From: Griffin, Tim (Contractor)
Sent: 28 November 2024 16:23
To: Harrison, Liz
Cc: Dyer, Tim; Ellison, Mark; Oliveira, Marta (Contractor)
Subject: CS/24/98535 Luminous Oak SEMH School, Flycatcher Road, Boorley Gardens - Landscape comments

Terra Firma General Arrangement Plan

Proposed Site Plan

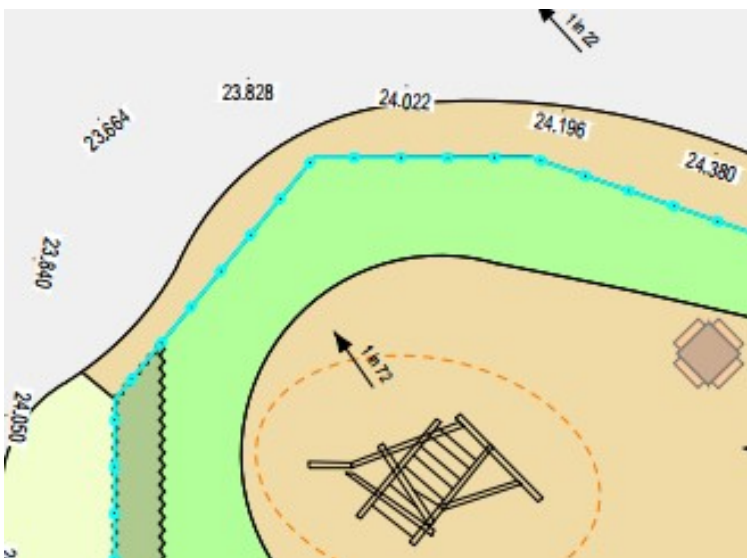
The general arrangement of the various site elements is acceptable, and the structure tree planting indicated is welcomed. These trees will soften views into site and filter internal views.

The parking and access drives are effectively softened with tree planting that will establish to provide shade and shelter.

The established Oaks along the northern boundary are an important feature in the local landscape, and it is comforting to know these will be retained unaffected by development of the site. It would be good to see some on site successional Oak tree planting along the northern boundary to bolster this landscape feature (see my further comments on the landscape plan that follow below).

The native hedging along the E, S & W boundaries will mature to create new wildlife corridors and is supported.

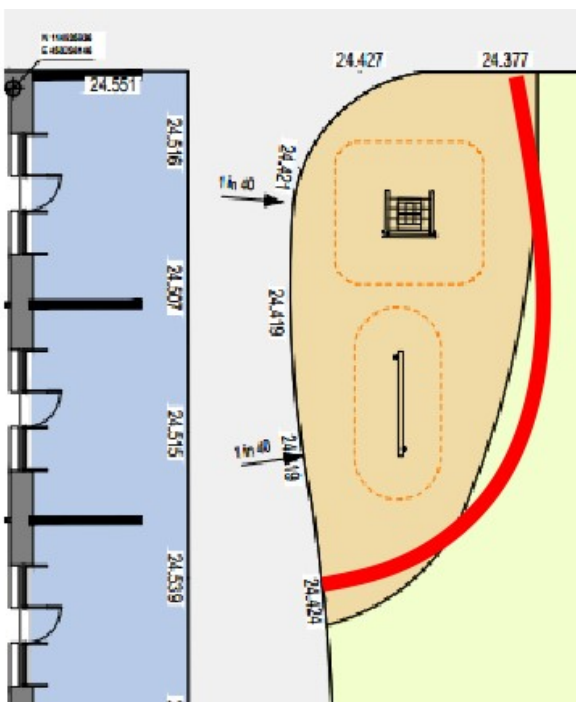
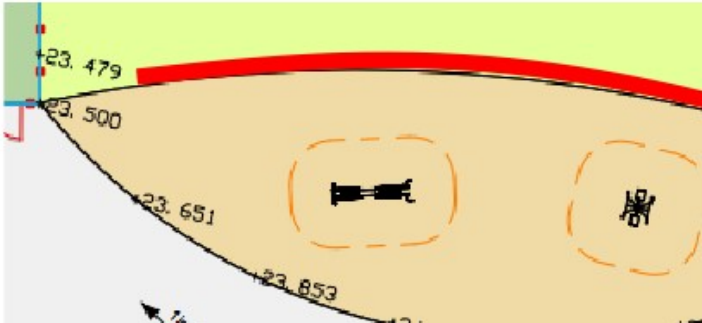
- a/ Arrivals at the main gates is rather underwhelming, with the area enclosed with exposed weldmesh fencing/gates. Could this be improved by planting a feature tree either side of the access road to frame the arrivals view (in areas of grass)? Additionally, could the native mix hedges extend to the W to soften the fence line?

- b/ There are extensive areas of Asphalt surfacing specified for drives and paths. Could the porous asphalt paths be a coloured material for added interest?

- c/ At the front of the site, a significant number of new trees are either planted in areas of asphalt or in narrower island beds. These trees are a critical part of the landscape structure. In order to ensure these trees survive and thrive long-term, specialist Silva cell tree pits will be required and details should be submitted.

- d/ Some informal sitting walls or benches adjacent the drop off/pick up zone would be sensible for waiting passengers. Some litter bins would also be advisable (is there a litter strategy for the site?).

- e/ Where planting abuts the sides/ends of parking bays, allow for access/runover strips to avoid the planting getting damage. A 1m high clipped hedge along the centreline of the island bays would help soften low level internal views.

- f/ The area of grass immediately to the W of the cycle store should be replaced with shrub planting and climbers to soften this structure.
- g/ This play space is potentially bland.

It is enclosed by a 2.4m high fence and there is little planting to soften the fences. Additional shrub or climber planting should be included.

The notional play equipment, raised planters and picnic table shown is rather sparse. Is there scope to include a central G.L. planter and small tree to provide shade in summer months? More detail on this and other areas of play is required.

Is there any reason why there is a strip of rubber mulch along the N side of the timber fence? Mixed shrub planting would be preferred.

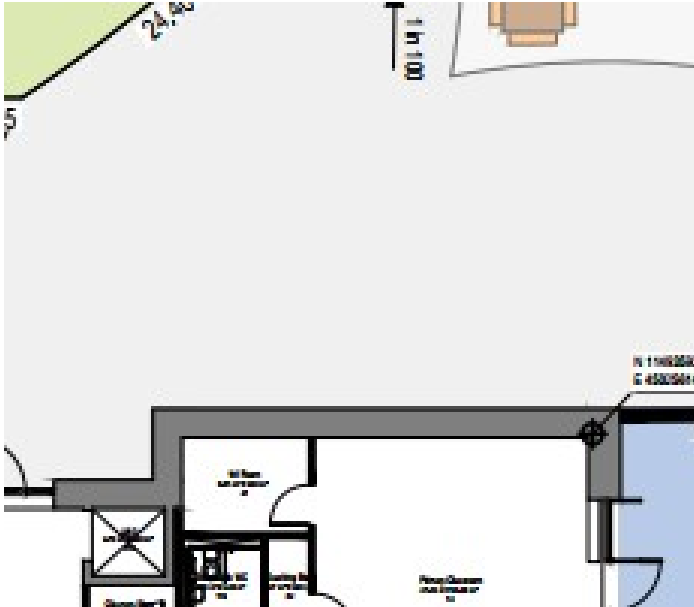
h/ 2 play areas will appear fairly exposed as drawn as there are no enclosing elements. I suggest the following:

j/ The line of offsite established Oaks is a prominent landscape feature. The site photo included in the DAS indicates that some of these Oaks are not especially healthy.

K/ Further detail is required on the Forest School area noted on plan. What does this include?

L/ Introduce a GL planter for shrub planting to soften the N facing flank wall below?

n/ Weldmesh fences to be dark grey or black (not green).
